Access Compliance Report

Public Rights-of-Way

(Curb Ramps)

Intersection ID: 4159	Main Street: COLVARD_CR	Cross Street: COLVARD_PARK_WY	Location: NE
ADA ID: 6B1F3410C13B	Ramp Type: BlendTrans1	Initial Pass/Fail: Pass	Overall Compliance: No
Severity Score: 14.25			
Codes/Mitigation Info/Possible Solution		Field Measurements/Component Compliance

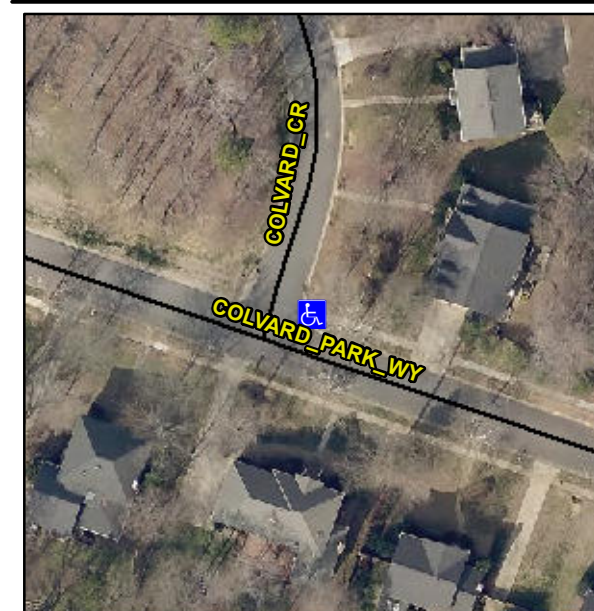
Not Found, R304.5.3, R304.2.1, R304.2.2-Perp, R304.3.2-Para, R305.1.4, R305.2, R302.7.2

Compliance	Description	Data	Compliance	Description	Data
N/A	Ramp Length (in)	40.0	Yes	BlendTrans Slope (%)	1.9
Yes	Ramp Width (in)	48.0	No	BlendTrans XSlope (%)	4.7
N/A	Flare Type LT	Sloped	N/A	Flare Type RT	Sloped
N/A	Flare Slope LT (%)	5.6	N/A	Flare Slope RT (%)	4.7
N/A	Flare Traversable LT?	No	N/A	Flare Traversable RT?	No
No	Landing Length (in)	46.0	Yes	DWS Provided?	Yes
No	Landing Width (in)	37.0	Yes	DWS Contrast?	Yes
No	Landing Slope (%)	6.1	Yes	DWS Length (in)	24.0
Yes	Landing X Slope (%)	0.7	No	DWS Full Width?	No
N/A	Landing Curb? (Y/N)	No	No	DWS Offset (in)	6.5
N/A	Shared Landing?	No			
Yes	Gutter Ponding?	No	Yes	Gutter Slope (%)	0.0
No	Gutter Lip Ht (in)	0.5	No	Gutter X Slope (%)	4.6
N/A	Painted X Walk1?	No	N/A	Painted X Walk2?	N/A
	X Walk 1 Direction	To W		X Walk 2 Direction	N/A
	X Walk 1 Width (in)	N/A		X Walk 2 Width (in)	N/A
	X Walk 1 Slope (%)	1.2		X Walk 2 Slope (%)	N/A
	X Walk 1 X Slope (%)	10.8		X Walk 2 X Slope (%)	N/A

N/A	Ramp inside XWalk1?	N/A	N/A	Ramp inside XWalk2?	N/A
	Road Slope (%)	10.8		Clear Space?	Yes
	Road X Slope (%)	1.2	N/A	Clear Space to XWalk (in)	N/A
Yes	Any Obstructions?	No	Yes	Storm Grate/Utility Hazard?	No
	Obstruction Type			Storm Grate/Utility Type	
		N/A			N/A
			Yes	Surface Condition? (G/P)	Good
			No	Curb Slope (%)	17.8

Remove & Replace Curb Ramp With Two New Directional Ramps or Equivalent. Remove & Replace Gutter.
